August 3, 1984

HOPE CREEK GENERATING STATION  
DOCKET NO. 50-354  
DRAFT SAFETY EVALUATION REPORT  
OPEN ITEM STATUS

In addition, enclosed for your review and approval (see Attachment 4) are the resolutions to the Draft SER open items, FSAR question responses and structural geotechnical audit item responses, listed in Attachment 3.

FIGURE A-13-15  
RESPONSE SPECTRA COMPARISON,

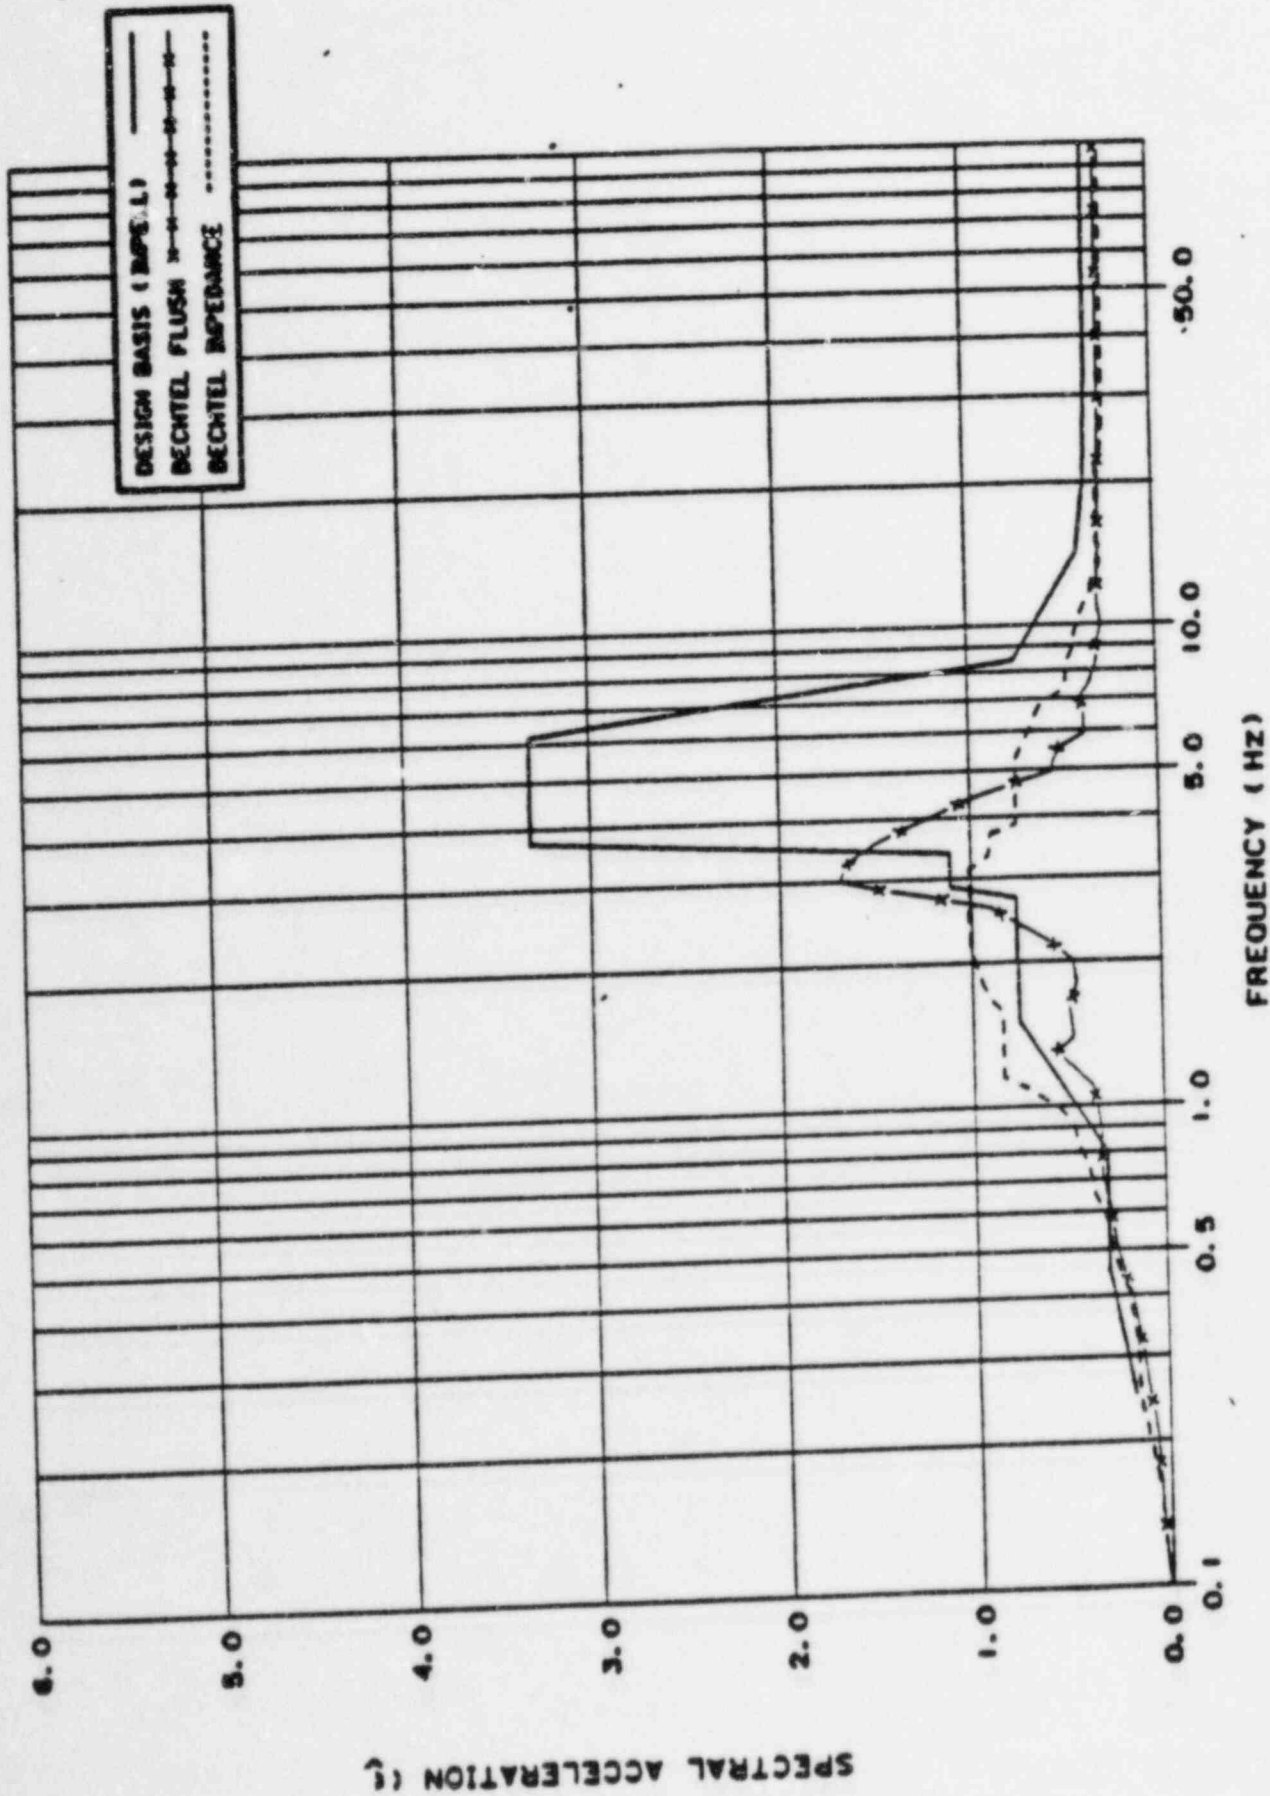
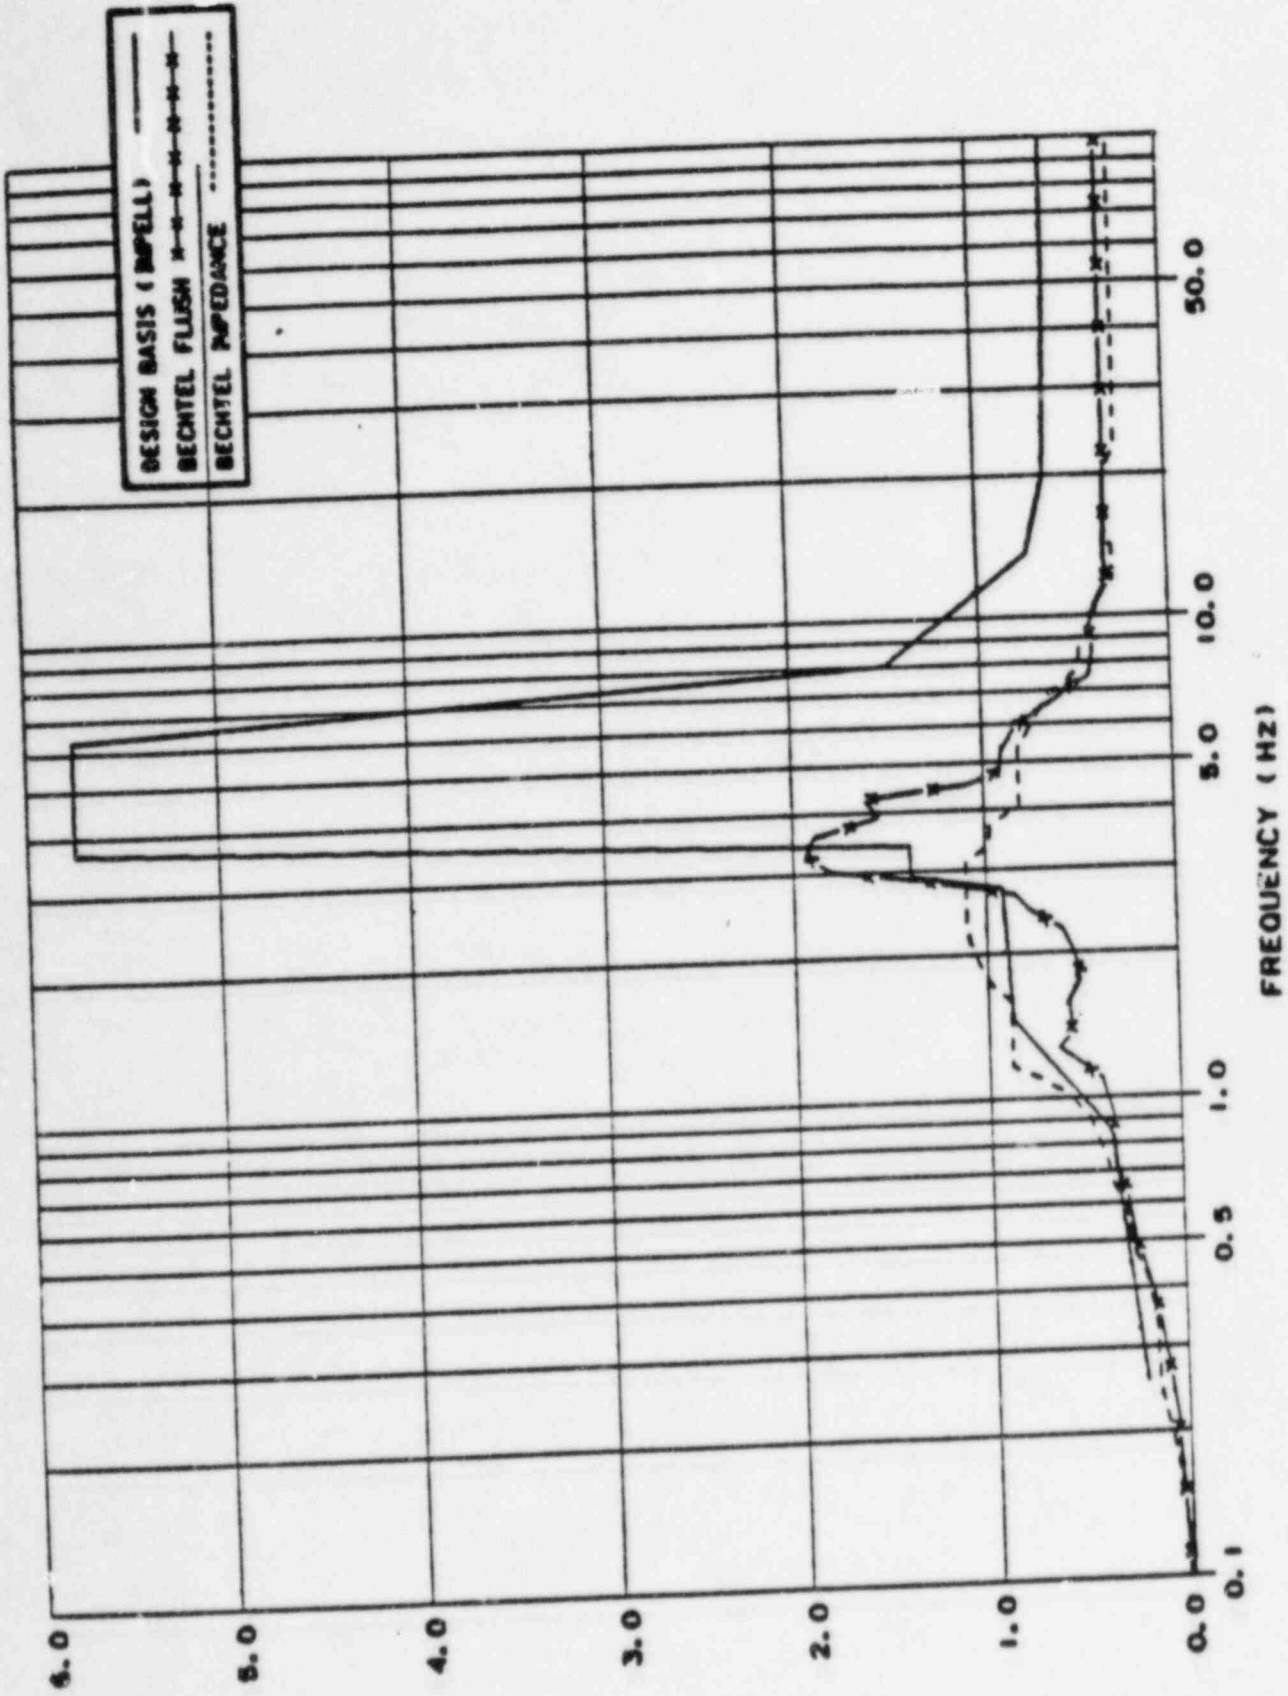
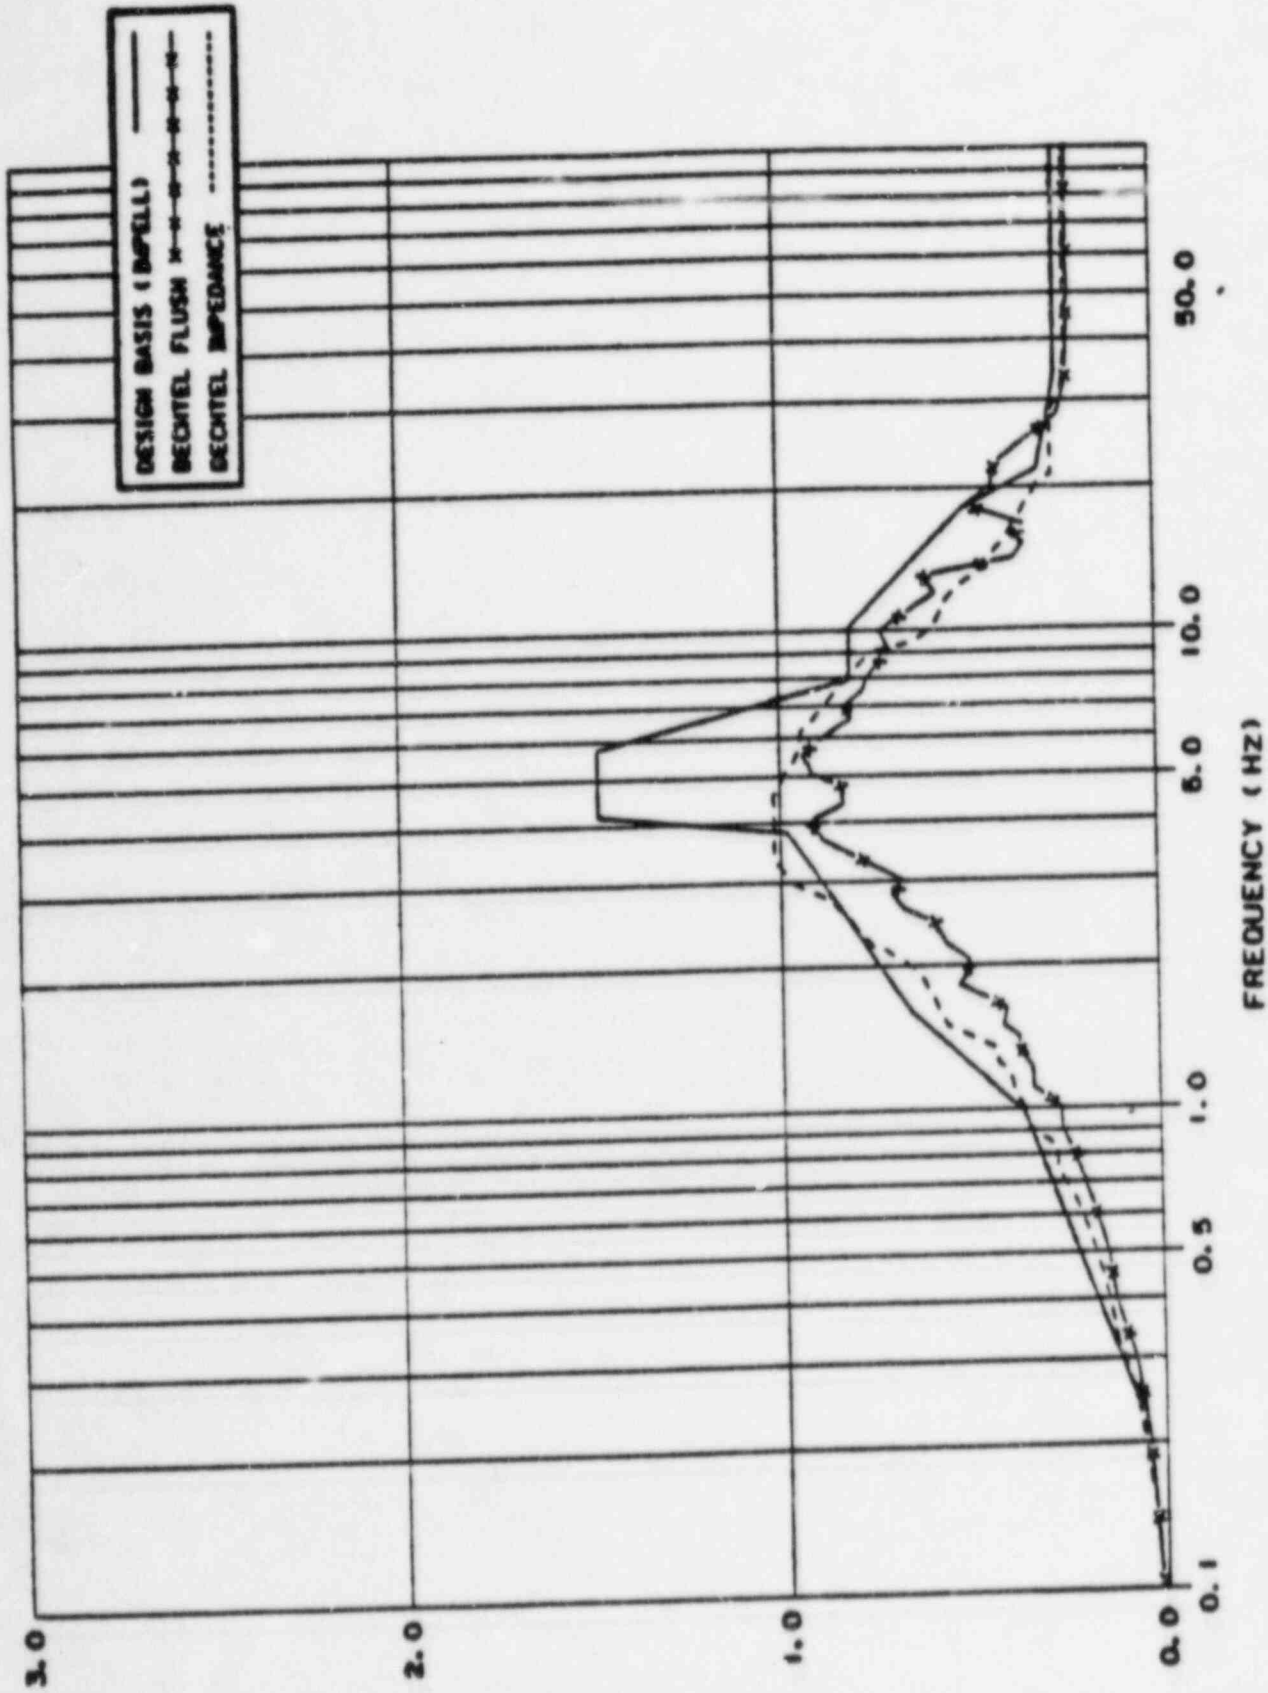
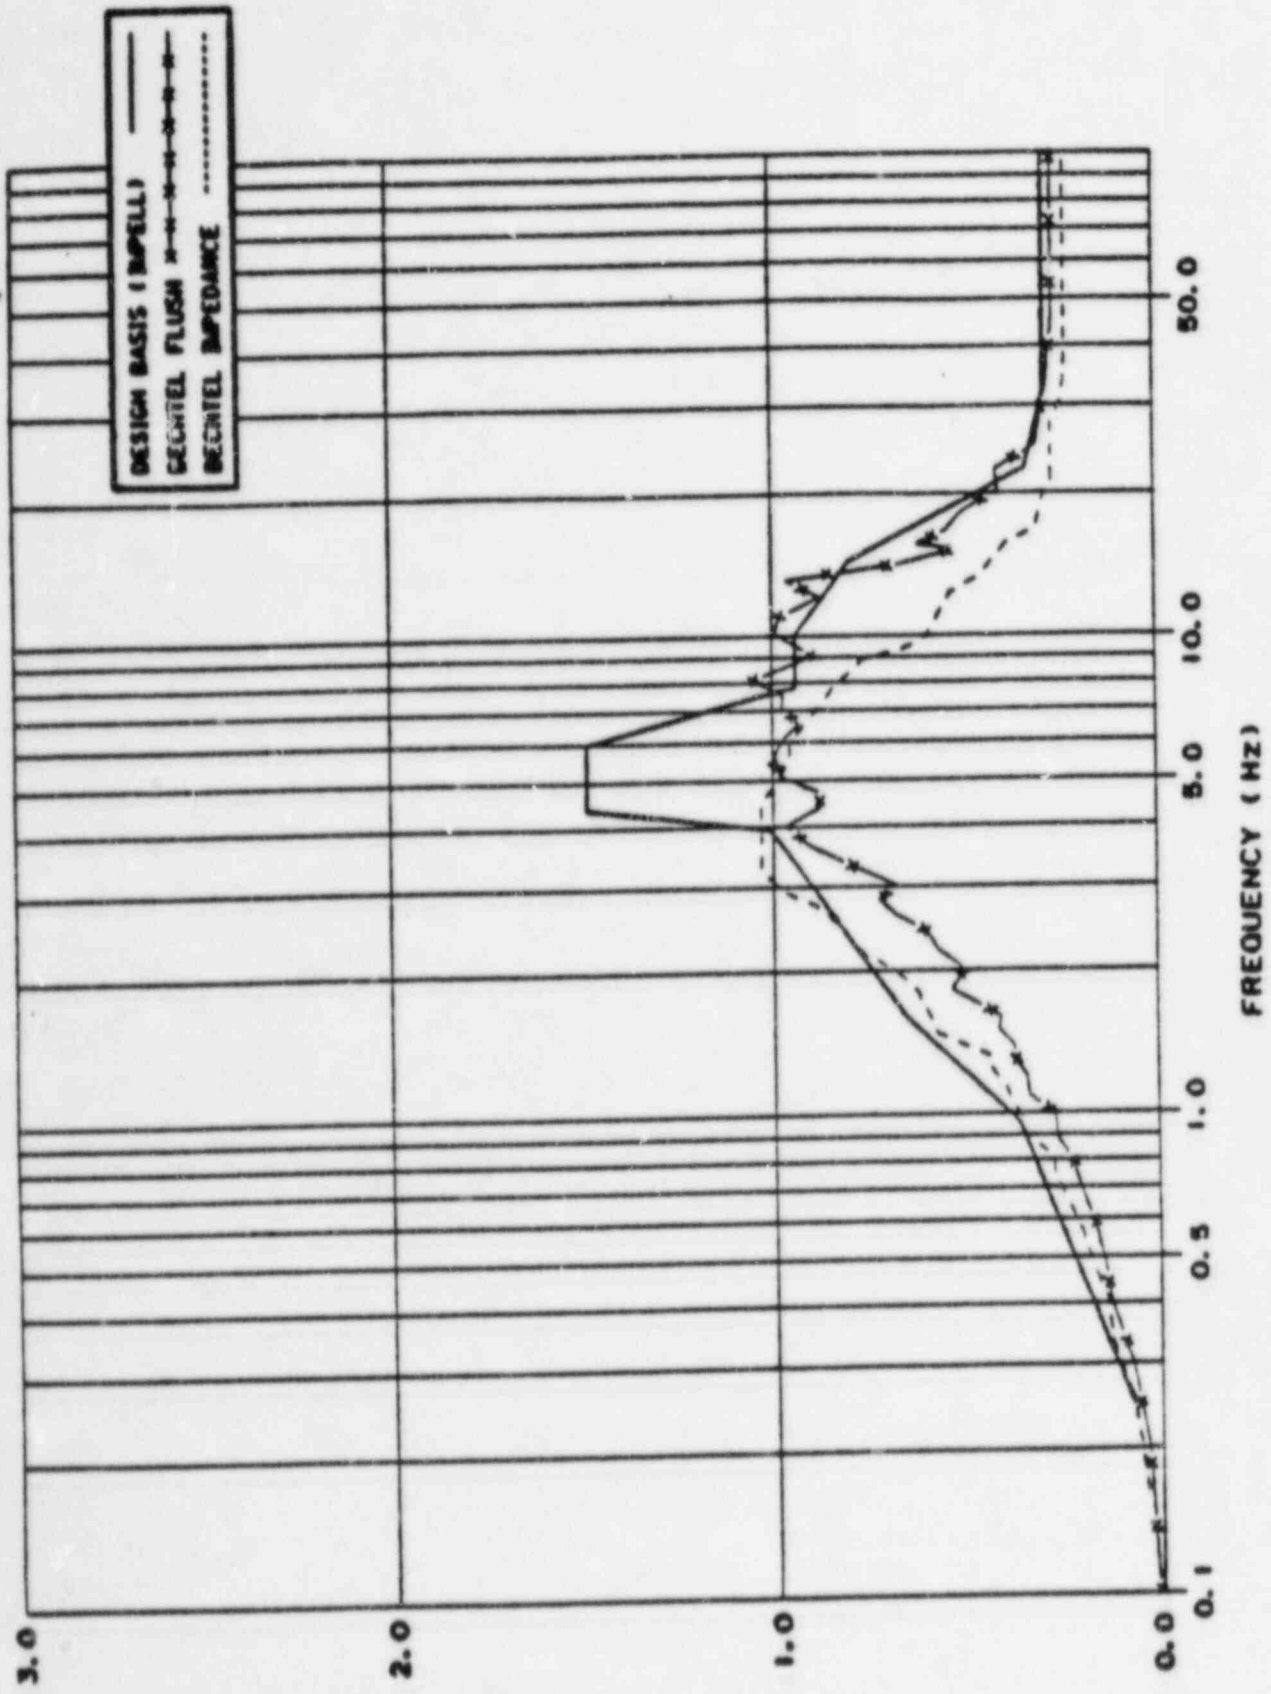
Question: Provide comparison of Bechtel Independent Verification Results with the Design Basis Results.

Figures A-13-2 to A-13-37 show the comparison of the response spectra (2% damping) obtained from the above three seismic soil-structure interaction analyses. Discussions of these comparisons are as follows:

Bechtel's independent soil-structure interaction analyses are performed using the computer code FLUSH. The results of independent finite element analyses are in reasonable agreement with those of the design basis analyses. As can be seen from Figures A-13-2 through A-13-37, the horizontal response spectra obtained from the independent finite element analyses are generally enveloped by those obtained from the design basis analyses except for the frequency range lower than 2 Hz. The vertical response spectra showed some exceedances at the frequency range of 18 Hz. These exceedances are listed in Table A-13-1.

The peak spectral accelerations obtained from the impedance approach analyses are generally lower than those obtained from the design basis analyses. However, these response spectra are not completely enveloped by those obtained from the design basis analysis, especially in the frequency range between 1.0 and 3.5 Hz. Also, there are some local exceedances in the higher frequency range, as shown in Figures A-13-2 through A-13-37.
